RBG-46376

SUBJECT: Application for Technical Specification Improvement To Eliminate Requirements to Provide Monthly Operating Reports and Occupational Radiation Exposure Reports

> River Bend Station, Unit 1 Docket No. 50-458 License Amendment Request (LAR 2004-23) License No. NFP-47

5.0-17

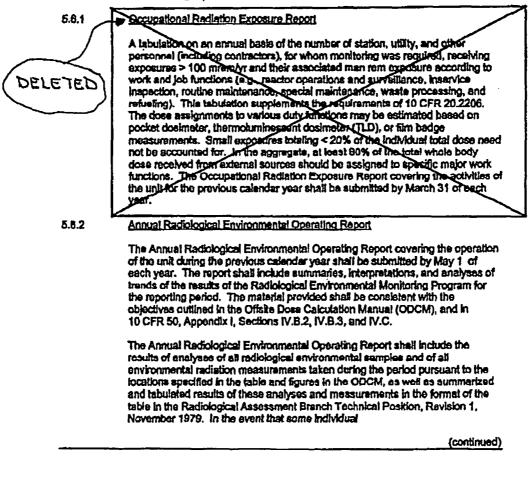
The proposed License amendment deletes the requirements in Technical Specification (TS) 5.6.1 for an annual report on occupational radiation exposures and TS 5.6.4 for a monthly report of operating statistics and shutdown experience.

TS 5.6.1	.1 Occupational Radiation Exposure Report		
TS 5.6.4	Monthly Operating Reports	Deleted
